**NOTIFICATION OF ADDENDUM
ADDENDUM NO. THREE
DATED: May 2, 2022**

**Parmer Ranch Blvd Phase 2 and Parmer Ranch Off-Site Wastewater Interceptor - Phase B
City of Georgetown Williamson County, Texas**

- Sheets 3, 33, 45, 49 and 77 from the Parmer Ranch Blvd Phase 2 - Bid Set were Revised
- No Sheets from the Off-Site Wastewater Interceptor - Bid Set were Revised

DETENTION & WATER QUALITY POND E PLAN
PARMER RANCH BLVD PHASE 2
 City of Georgetown
 Williamson County, Texas

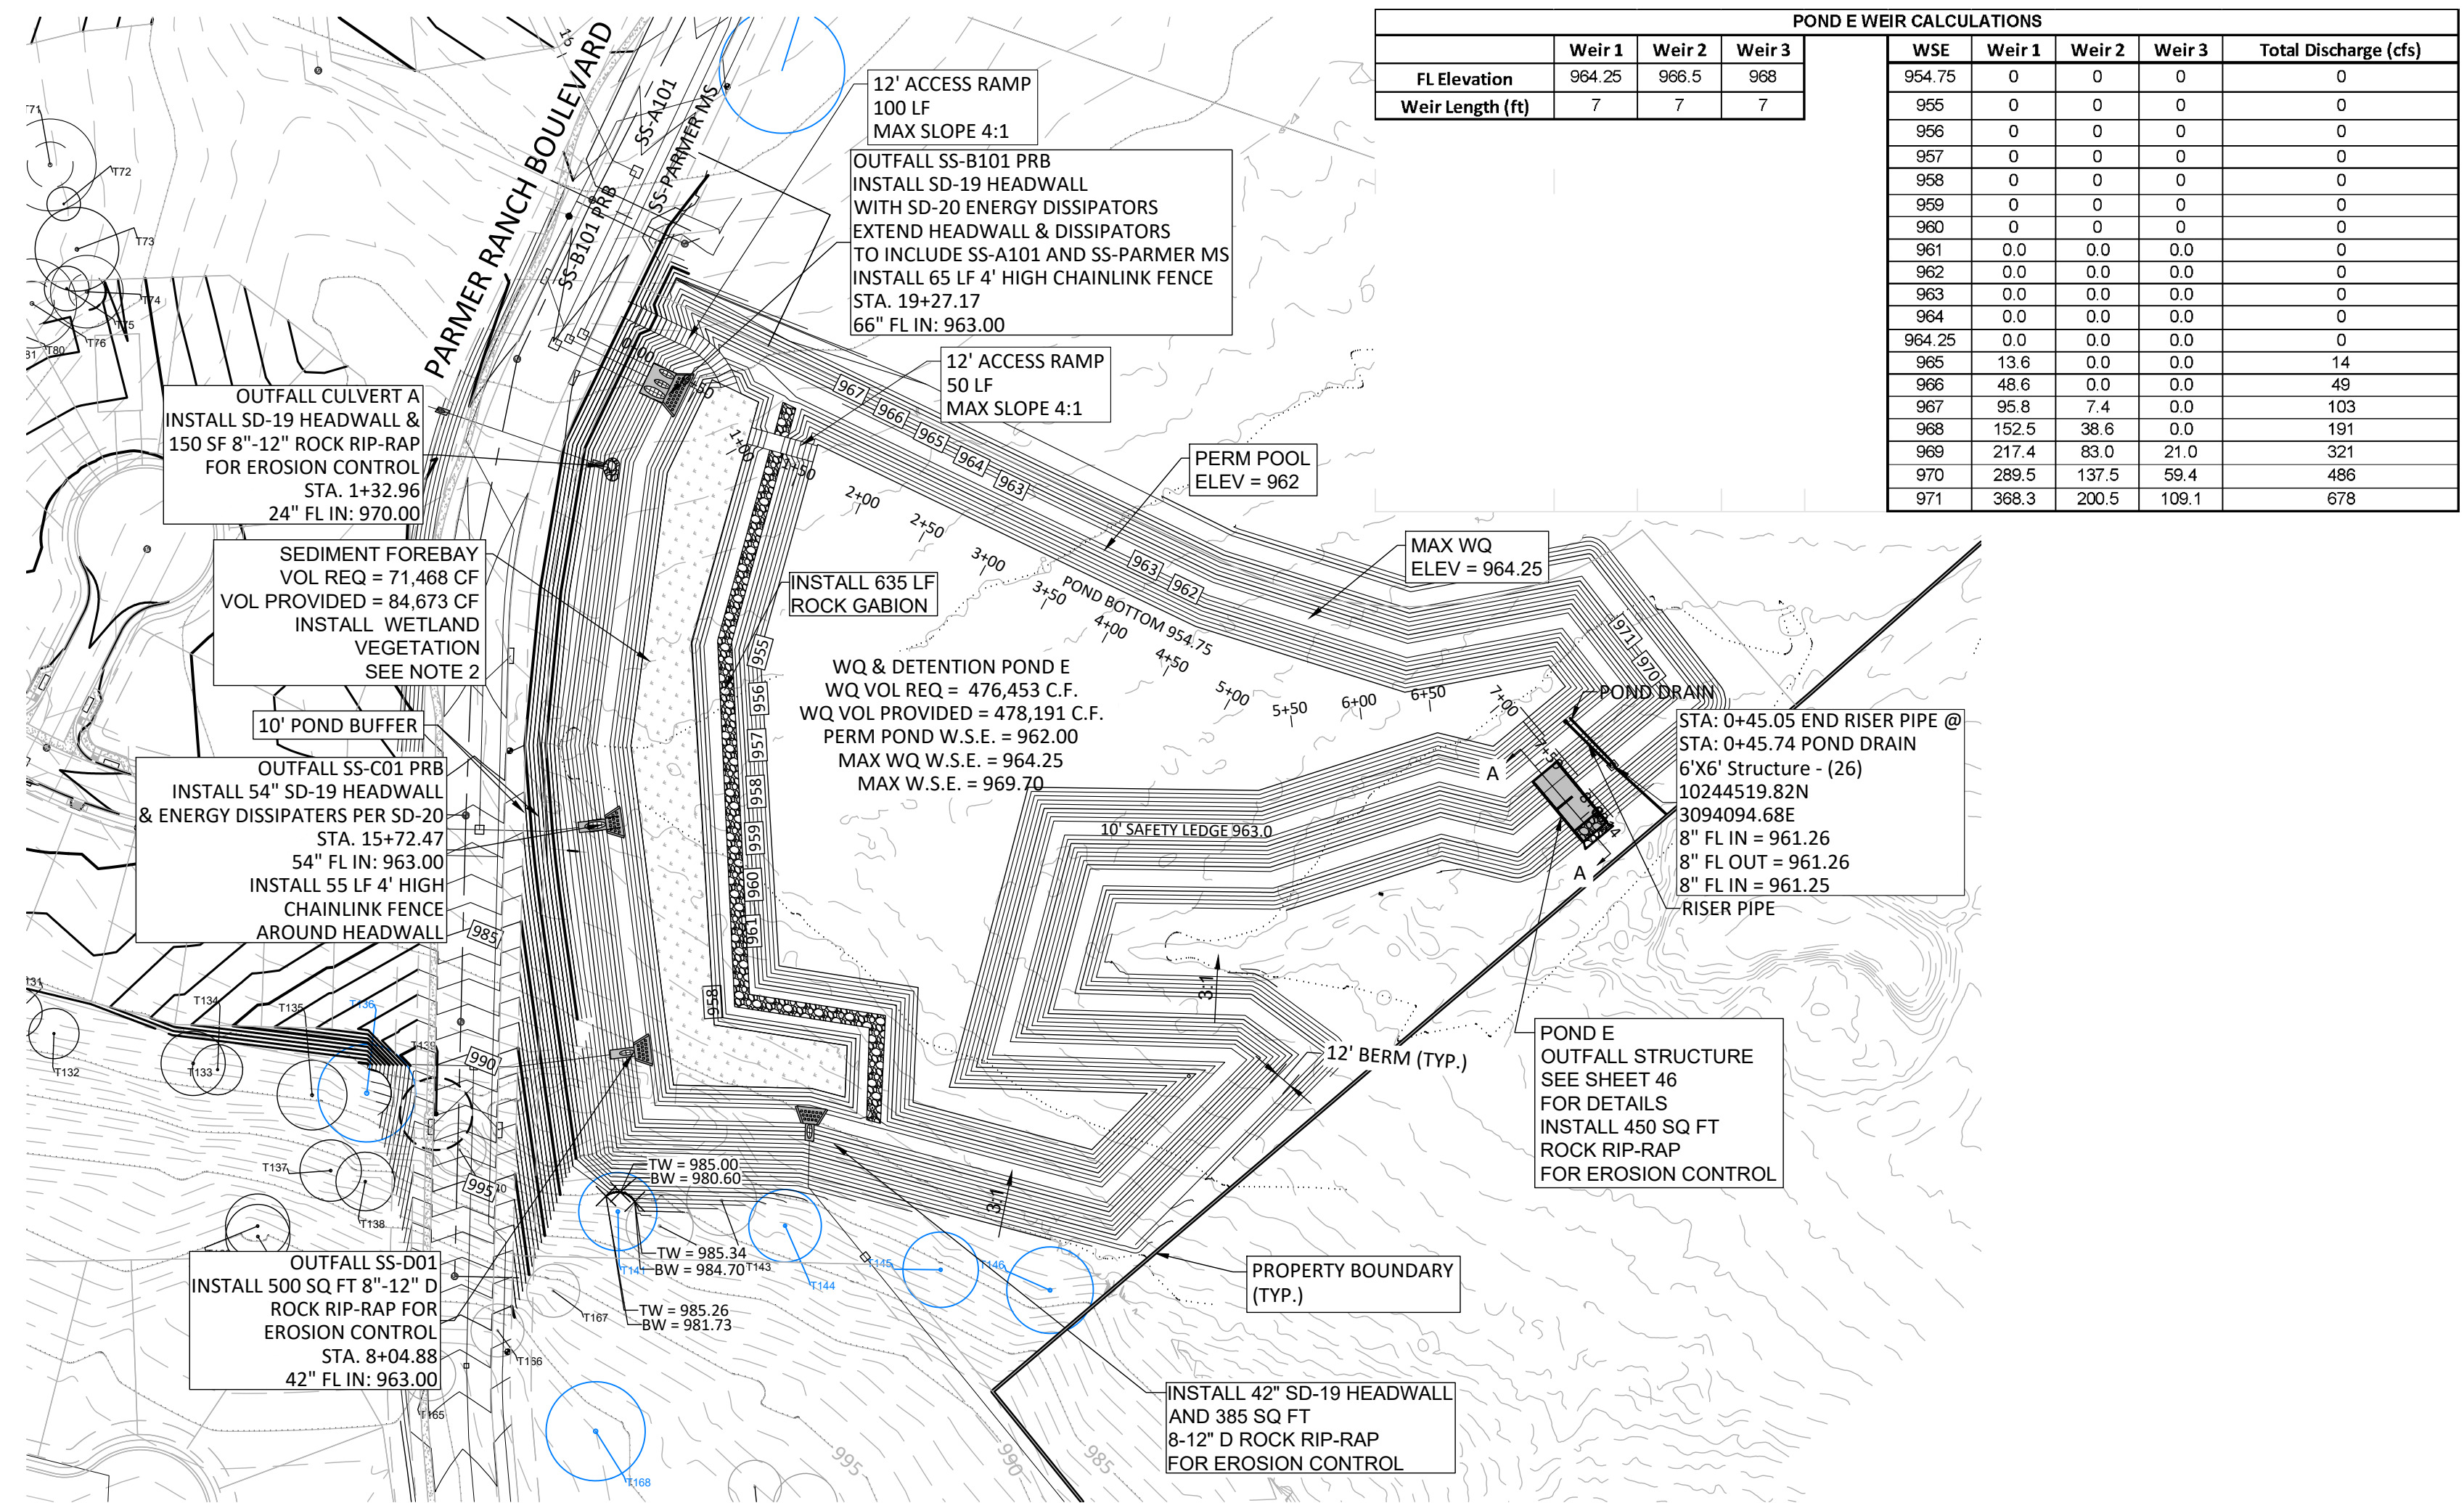
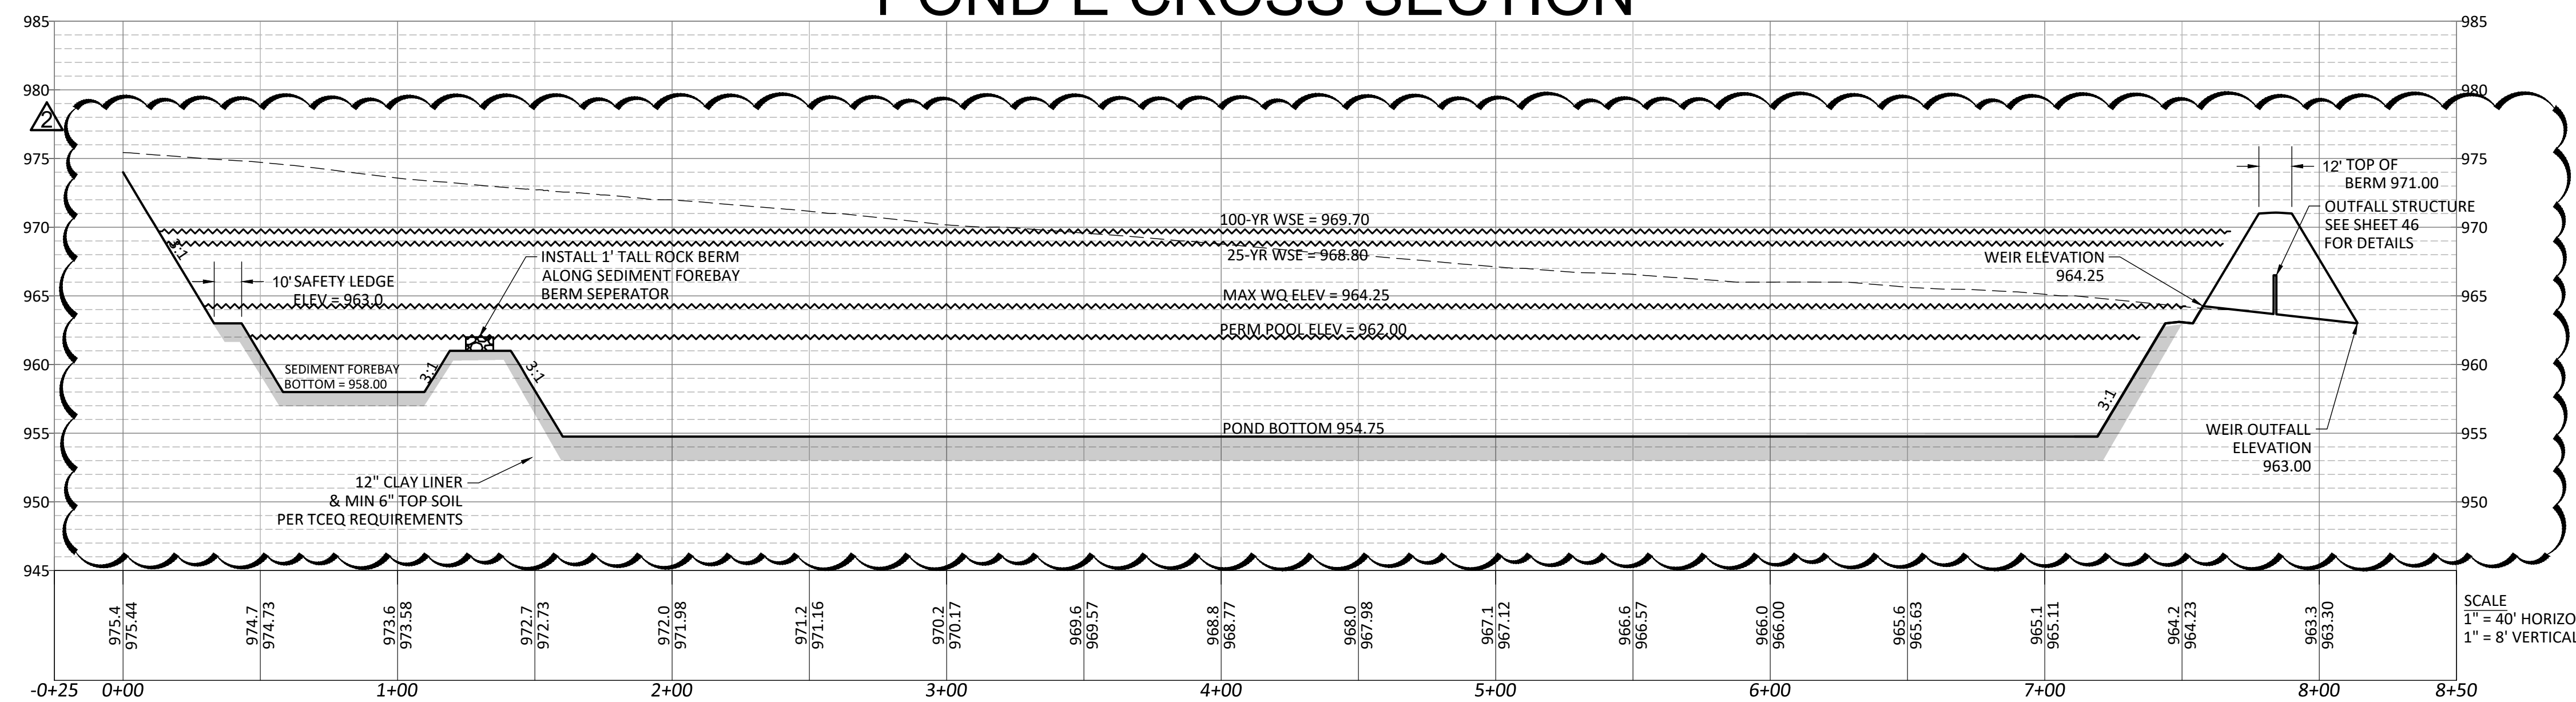
21. Sheet 45 appears to contain a scale that is incorrect, needs clarification.
Sheet 45 has been revised to show the correct plan view scale of 1"=100'. Profile Scales remain unchanged and are as noted.

22. Can you clarify how far above the PPE we are to extend the clay liner?
Extend the clay liner 1' above the PPE; Elevation 963'
23. The bid tab calls for a 4' Diameter Box the plans call for a 6'x6' please clarify.
The plans correctly call out a 6'x6', the bid item has been updated in the quantities table.

25. Is the tree well that is shown on sheet 45 subsidiary to the pond or is it included in the tree well item under ROUGH EXCAVATION/SUBGRADE/BASE PH 2?
The tree well is included in the Bid Item.

NO.	REVISION	BY	DATE
2	UPDATED PLAN SCALE AND CLAY LINER	TG	5/02/22

Residential Streets (Typ.)

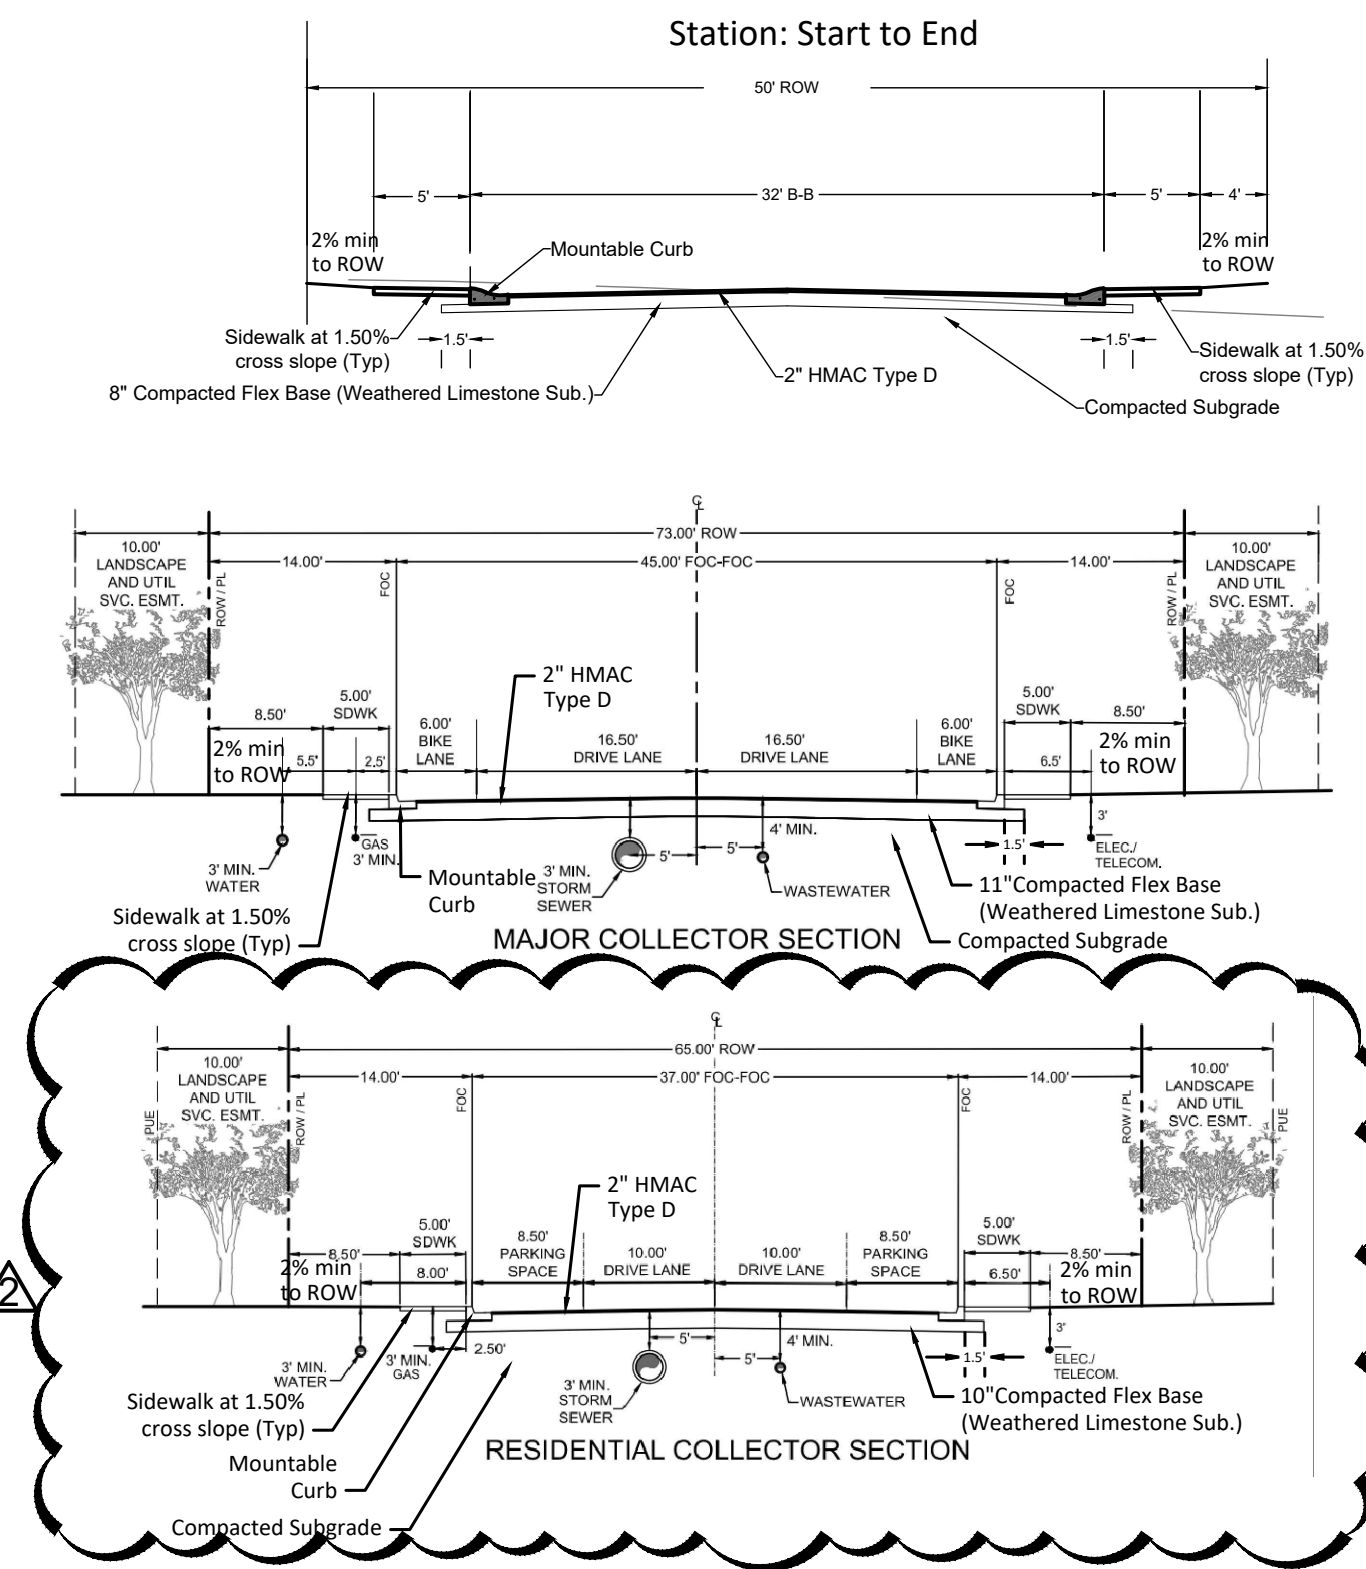
12. Can you provide detail or note that specify the street section for the lift station?
The lift station access drive shall be 2” HMAC over 11” of Base from the concrete SD-15 driveway north to the end.

NO.	REVISION	BY	DATE	DATE
2	ADDED STREET CROSS SECTION	TG	5/02/22	2021-09-20
